DEVELOPMENT REVIEW COMMITTEE (DRC) COMMENT REPORT

PROJECT NAME: Publix

CASE NUMBER: UDP-S21004

REQUEST: Site Plan Level II Review: 32,783 Square Feet of Commercial Use

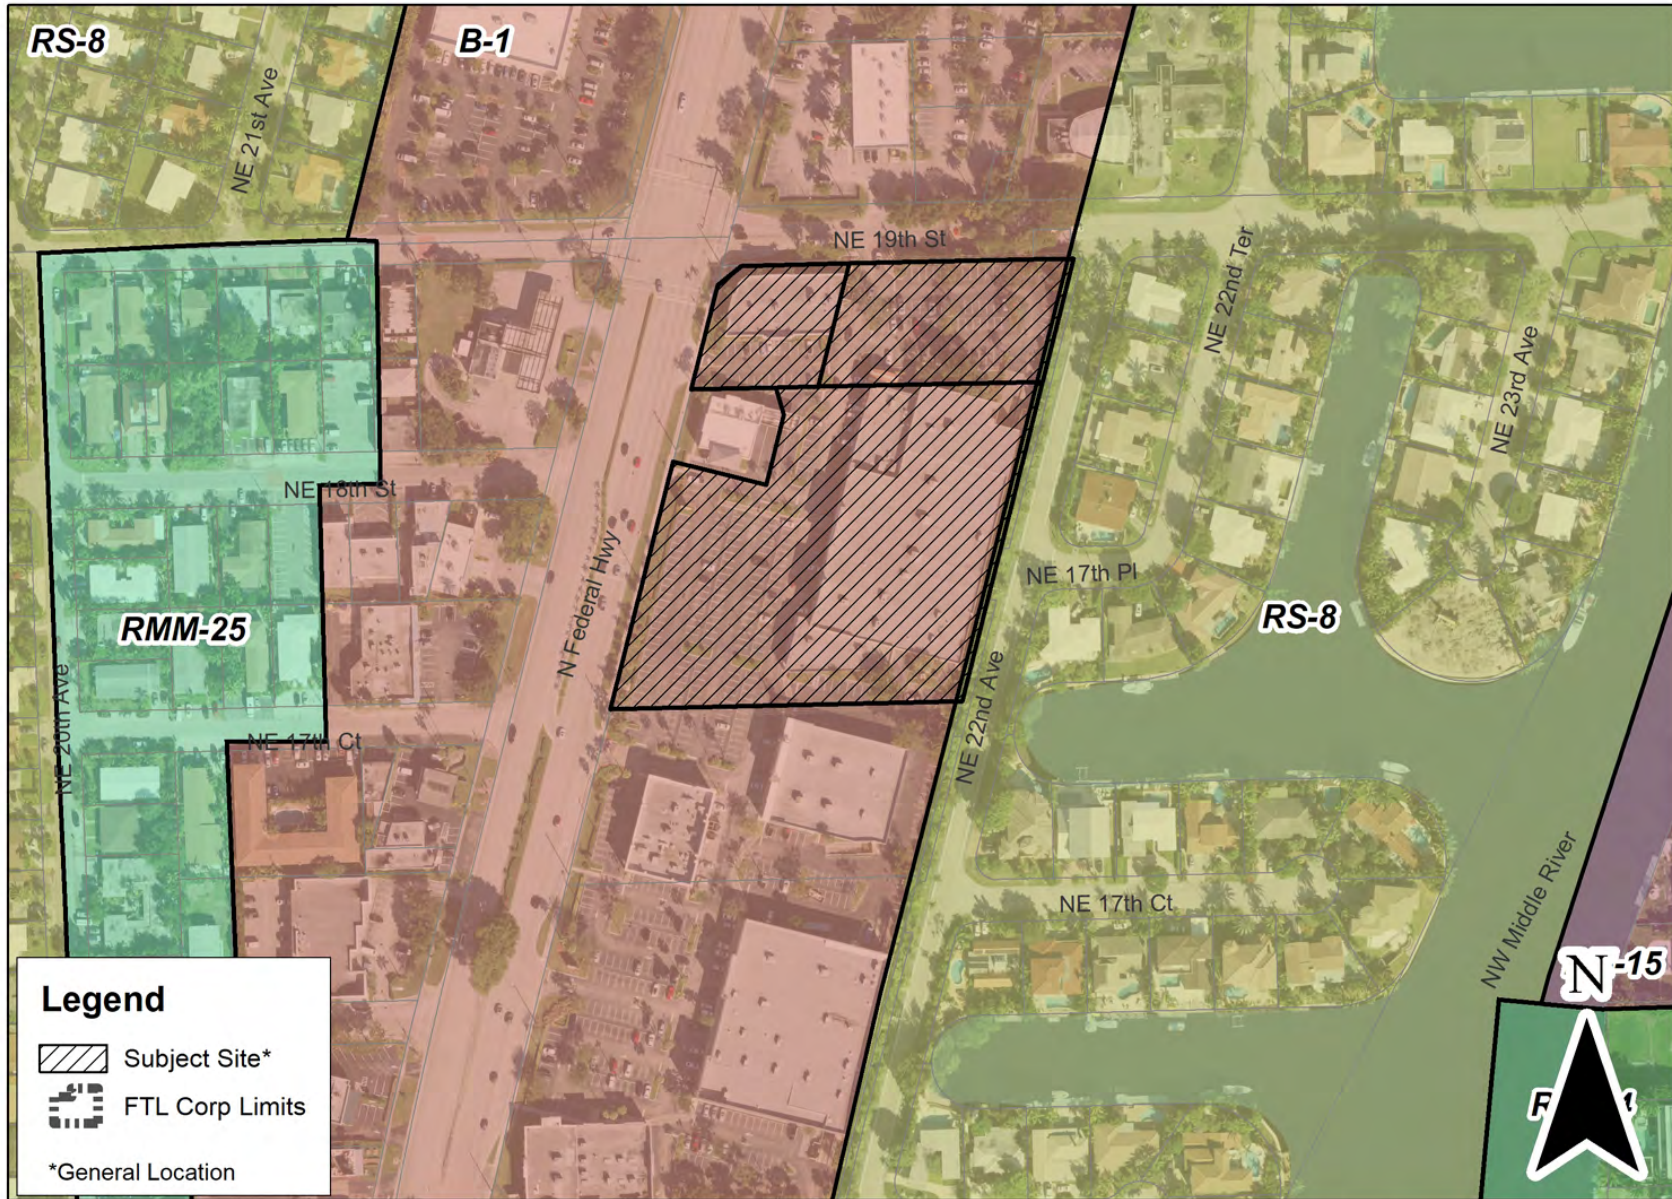
- i. Provide for more landscape material such as palms in the planter area in front of the building. See images below.
